MONTGOMERY COUNTY HISTORIC PRESERVATION COMMISSION
STAFF REPORT

Address:	7305 Takoma Avenue, Takoma Park	Meeting Date:	6/14/2023
Resource:	Contributing Resource Takoma Park Historic District	Report Date:	6/7/2023
Applicant:	Richard Henrich	Public Notice:	5/31/2023
Review:	HAWP	Tax Credit:	N/A
Permit Number:	1033753	Staff:	John Liebertz
PROPOSAL:	Installation of solar panels

STAFF RECOMMENDATION

Figure 4: The proposed solar arrays and exterior conduit (red line) at 7305 Takoma Avenue.

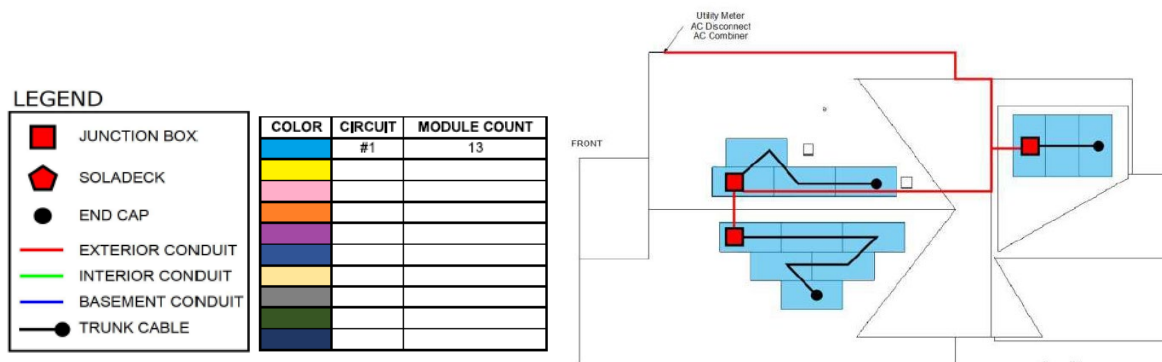
Staff recommends approval for the placement of exterior conduit wire with a condition. *Policy Guidance #20-01: Solar Technology (2021)* states that all conduits for connections to electrical meters should be placed on the inside of the building or on a secondary elevation. The proposal includes conduit wire running along the ridge of the rear addition to the west elevation (Figure 4). This conduit should be placed within the building to the greatest extent possible or tucked under the overhanging eave on the west elevation to reduce visibility from the public rights-of-way. Staff requests the applicant submit justification for the exterior conduit and a drawing/annotated photograph that illustrates the location of the exterior conduit (if required).

Staff recommends approval for the placement of the all exterior disconnects and combiners for the solar array with a condition. While this equipment is placed within view of the public right-of-way on the west elevation (towards the front porch), it is adjacent to an existing utility meter and would not further diminish the integrity of the resource. The applicant should submit specification sheets for all exterior hardware and an annotated photograph that illustrates its approximate location on the elevation.

1. The applicant shall submit justification for the exterior conduit (instead of an interior placement) and an elevation/annotated photograph that illustrates the location of the exterior conduit if required
2. The applicant shall submit specification sheets for all exterior inverters, combiners, etc. and an annotated photograph that illustrates their approximate location adjacent to the existing utility meters.
